Office Action Summary	Application No. 10/776,487	Applicant(s) YU, HO-YUAN	
	Examiner Khiem D. Nguyen	Art Unit 2823

DETAILED ACTION

3. Claims 21-24 and 26-34 are rejected under 35 U.S.C. 102(e) as being anticipated by Kumar et al. (U.S. Pub. 2002/0167011).

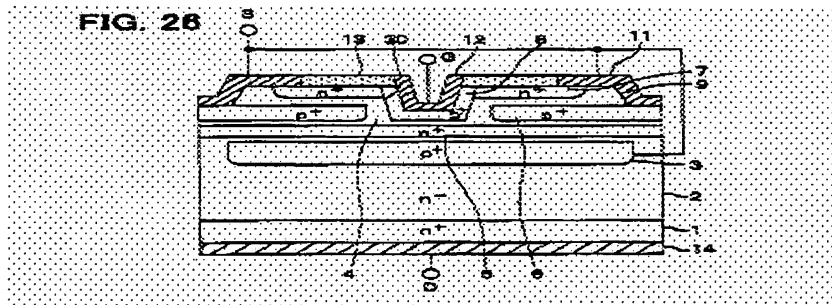
In re claim 21, **Kumar** discloses a method for fabricating a dual gate structure for a field effect transistor (FET), the method comprising: in sequence, etching a gate trench 30 in a surface of a semiconductor substrate 1 (page 7, paragraph [0156] and FIG. 22A);

forming a first gate region 8 at the bottom of the gate trench 30 (page 7, paragraph [0160]); implanting a buffer region 5 beneath the first gate region 8 (page 7, paragraph [0158] and FIGS. 22 A and 23A); and

implanting a second gate region 3 beneath the buffer region 5, wherein the second gate region 3 is formed entirely beneath the first gate region 8 (page 7, paragraph [0164] and FIG. 26).

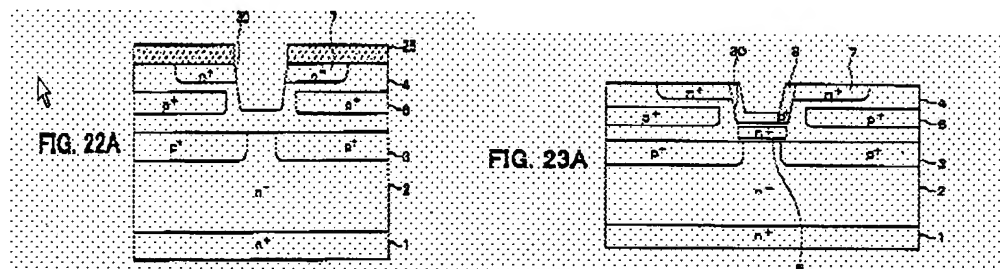
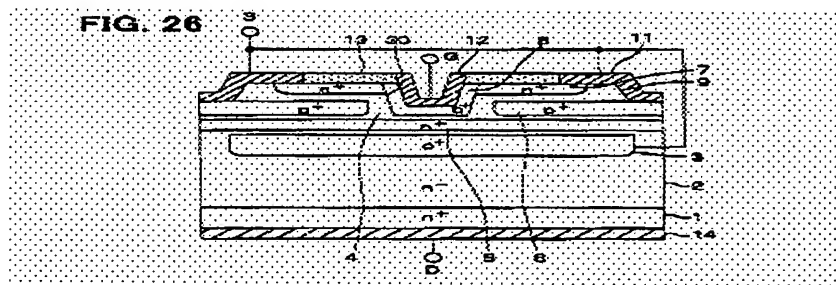
In re claim 26, **Kumar** discloses a method for fabricating a dual gate structure for a field effect transistor (FET), the method comprising: etching a gate trench 30 in a surface of a semiconductor substrate 1 (page 7, paragraph [0156] and FIG. 22A);

forming a first gate region 8 at the bottom of the gate trench 30 (page 7, paragraph [0160]); after forming the first gate region, implanting a buffer region 5 beneath the first gate region 8 (page 7, paragraph [0158] and FIGS. 22A and 23A); and

implanting a second gate region 3 beneath the buffer region 5, wherein the second gate region 3 is formed entirely beneath the first gate region 8 (page 7, paragraph [0164] and FIG. 26).

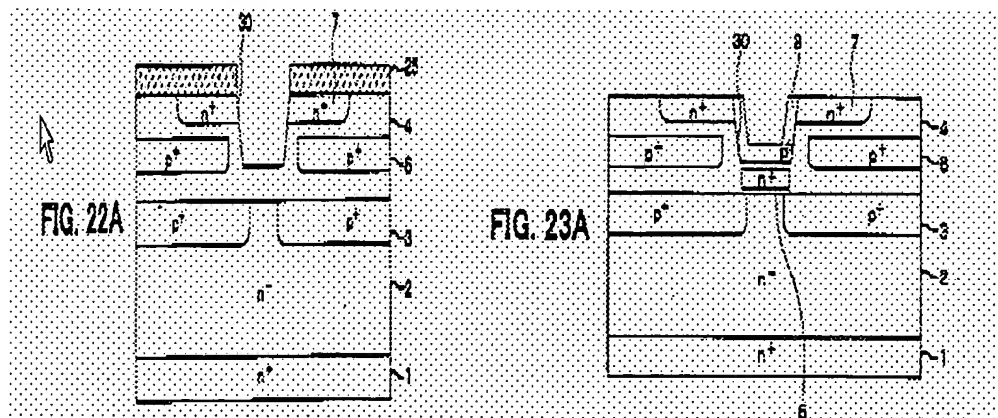
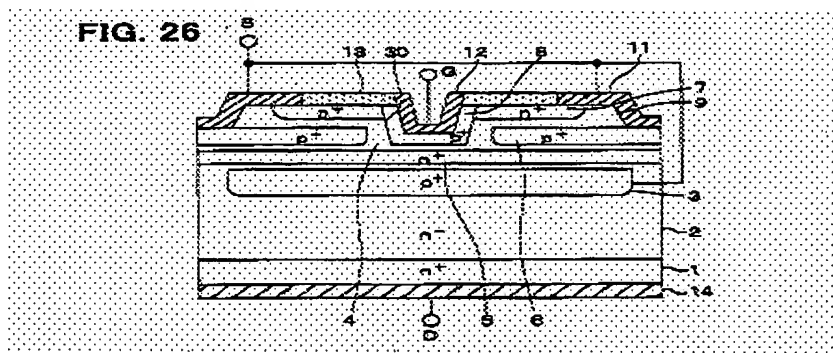
In re claim 30, **Kumar** discloses a method for fabricating a dual gate structure for a field effect transistor the method comprising: etching a gate trench 30 in a surface of a semiconductor substrate 1 (page 7, paragraph [0156] and FIG. 22A);

forming a first gate region 8 at the bottom of the gate trench 30 (page 7, paragraph [0160]); implanting a buffer region 5 beneath the first gate region 8 (page 7, paragraph [0158] and FIG. 22A and 23A); and

after implanting the buffer region 5, implanting a second gate region 3 beneath the buffer region, wherein said second gate region 3 is formed entirely beneath said first gate region 8 (page 7, paragraph [0164] and FIG. 26).
